May 15, 2019
BOARD OF COUNTY COMMISSIONERS
ORANGE COUNTY, FLORIDA

Y19-751-CH/Addendum #4

**CONNECTOR ROAD FROM HILTON DRIVEWAY TO APOPKA VINELAND ROAD
INTERSECTION IMPROVEMENTS**

Bid Opening Date: May 30, 2019

SHEET NO.
 62

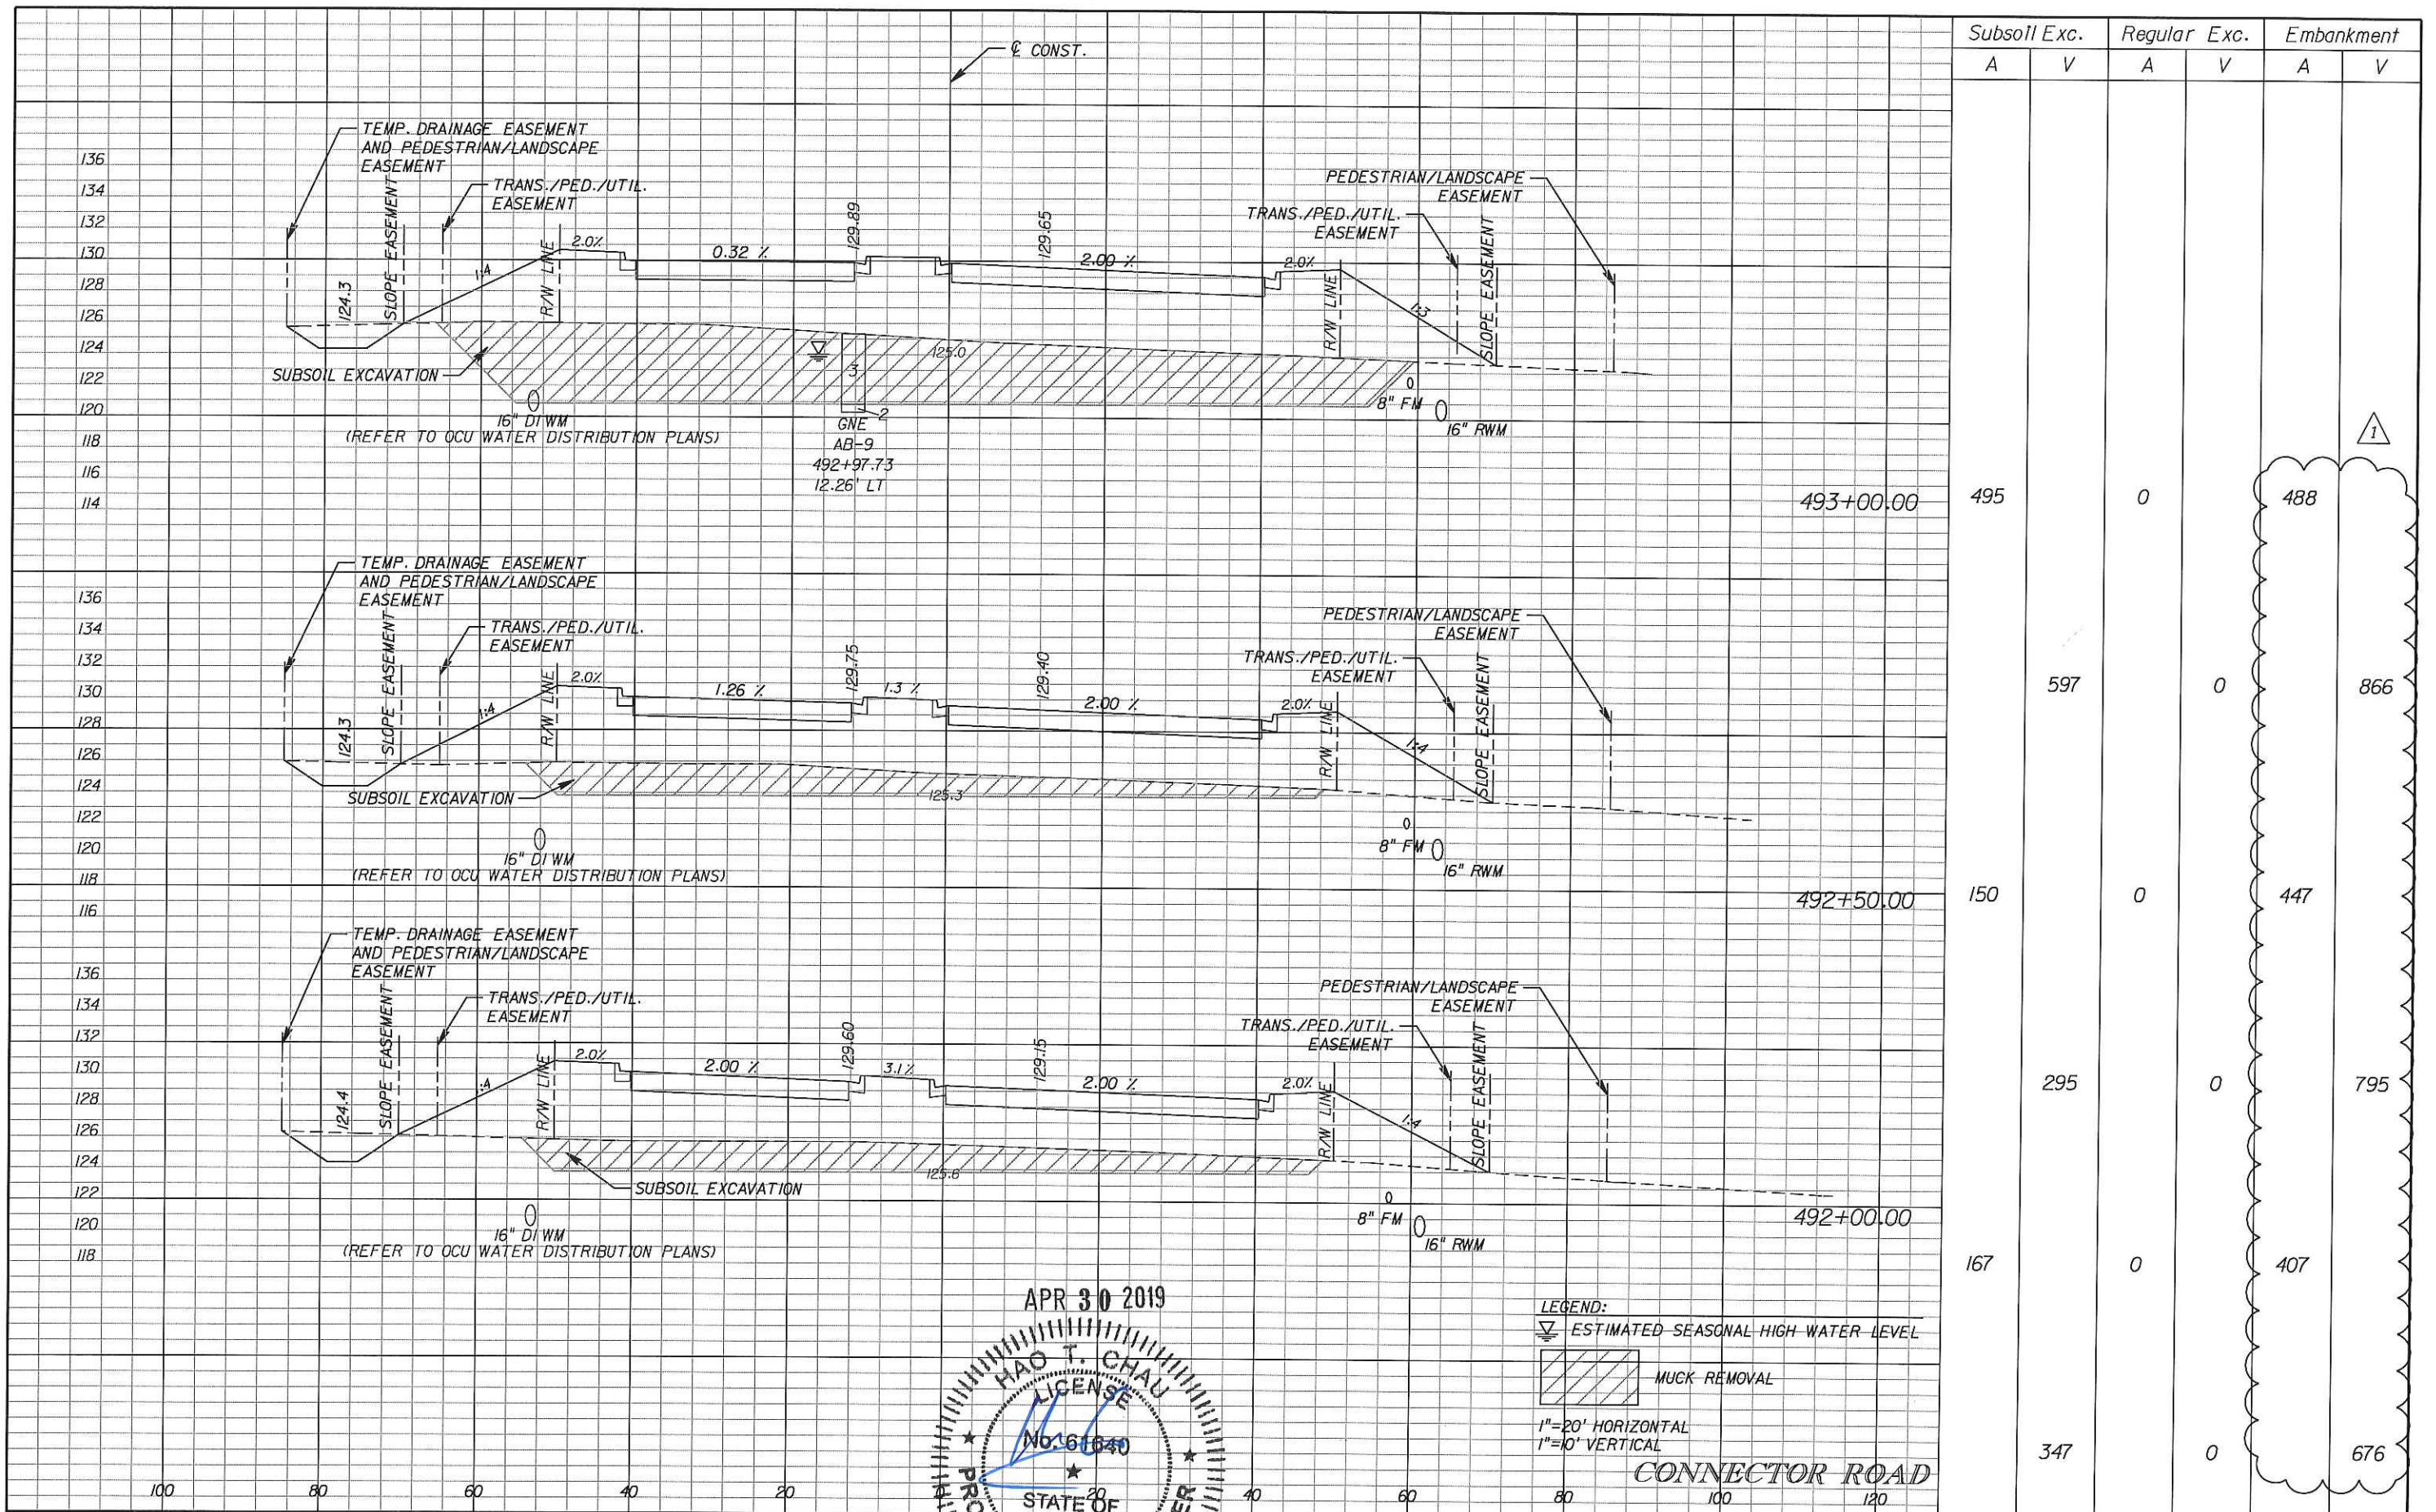
DATE	BY	DESCRIPTION	DATE	BY	DESCRIPTION
04/30/19		1 REVISED EMBANKMENT QUANTITIES

SHEET NO.
 63

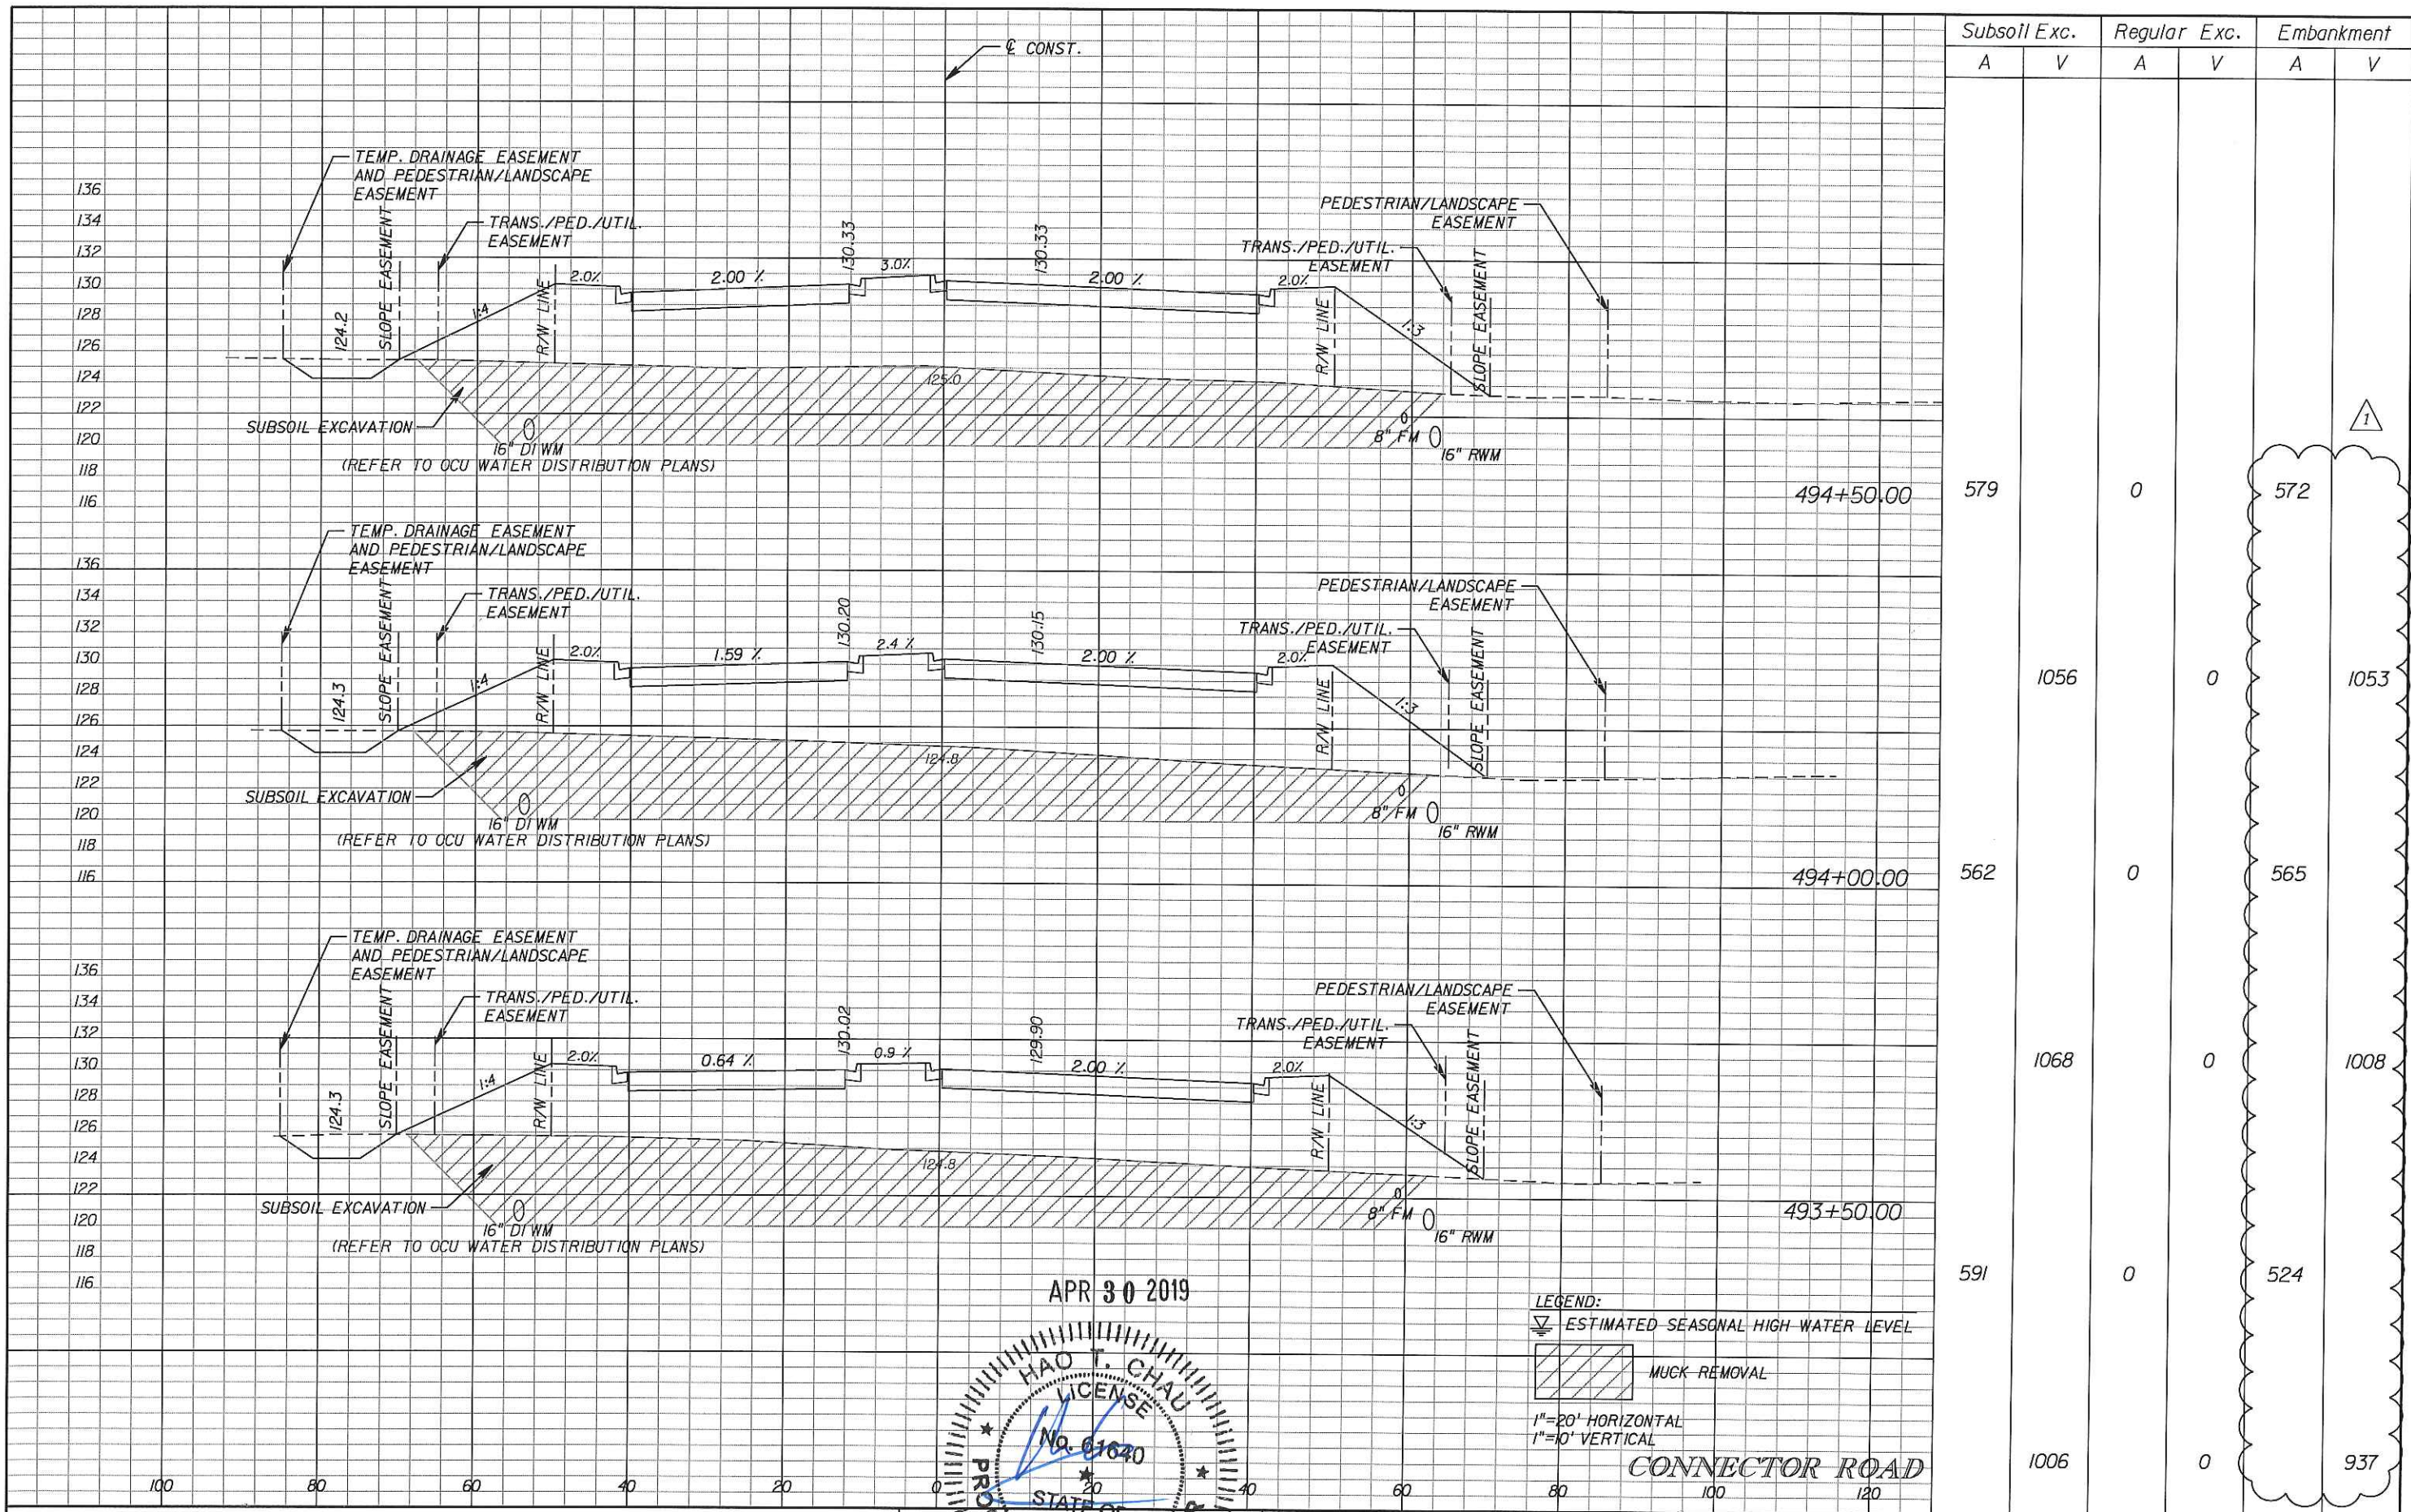
DATE	BY	DESCRIPTION	DATE	BY	DESCRIPTION
04/30/19		1 REVISED EMBANKMENT QUANTITIES

SHEET NO.
 64

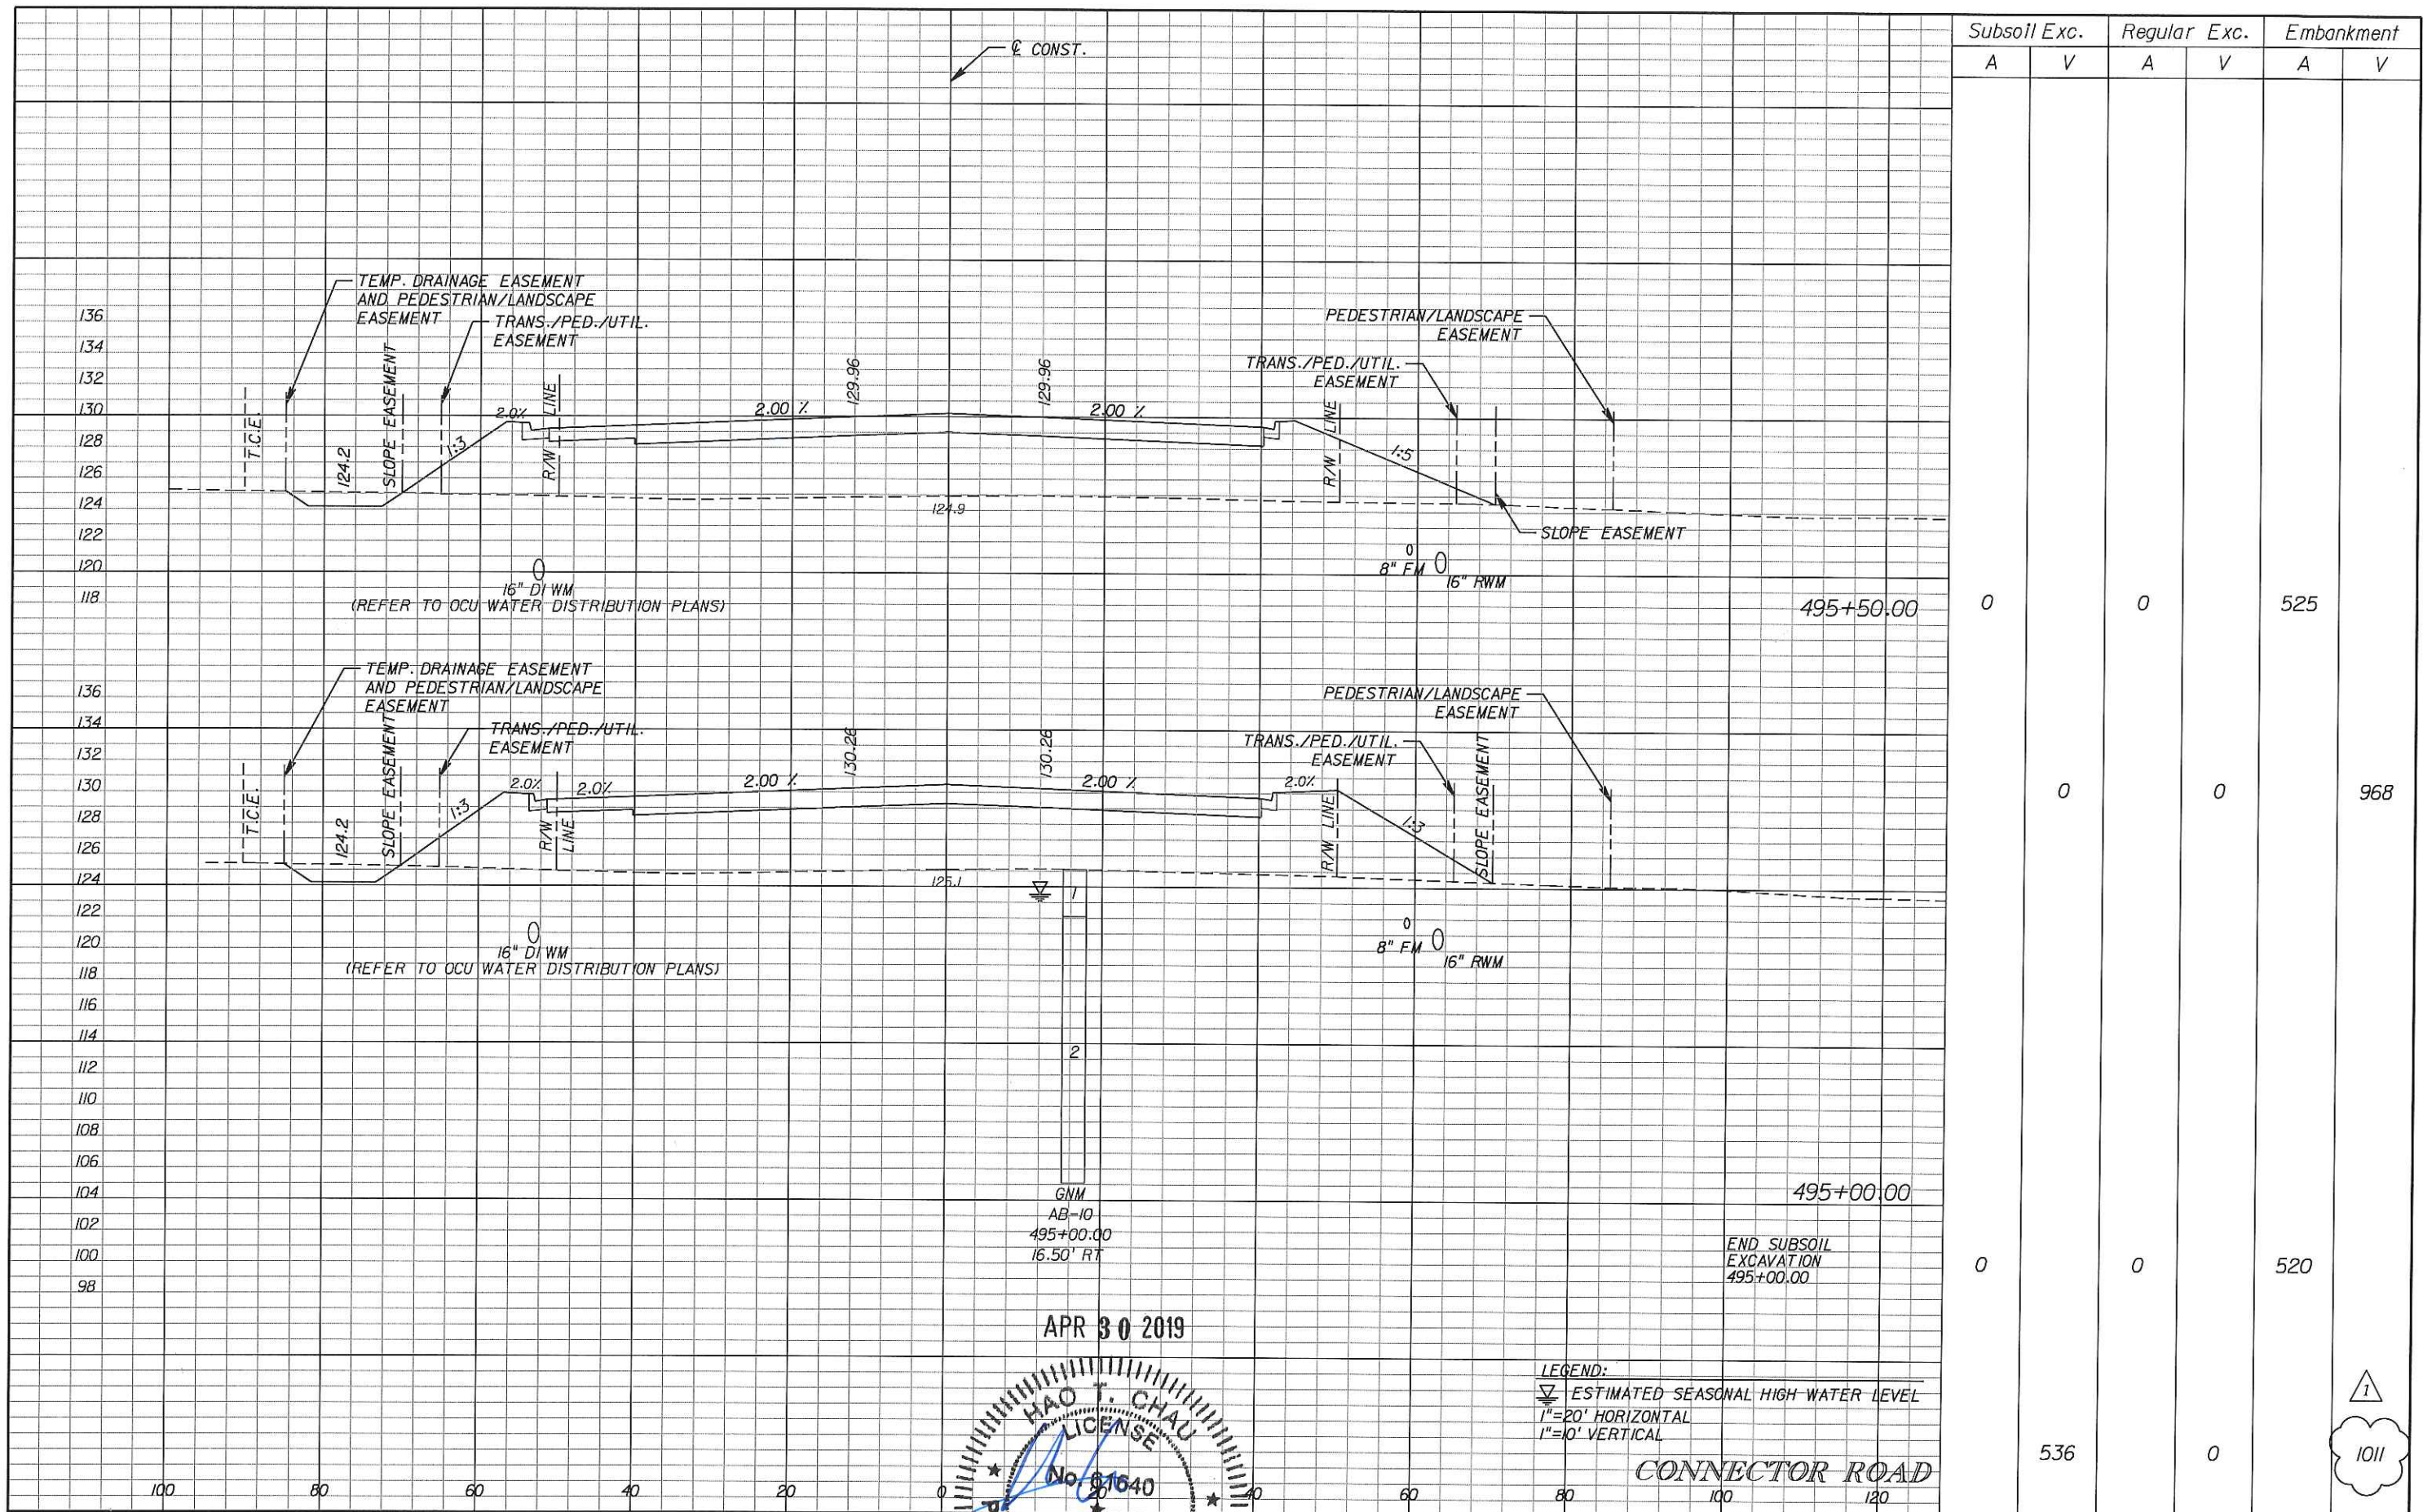
DATE	BY	DESCRIPTION	DATE	BY	DESCRIPTION
04/30/19		1 REVISED EMBANKMENT QUANTITIES
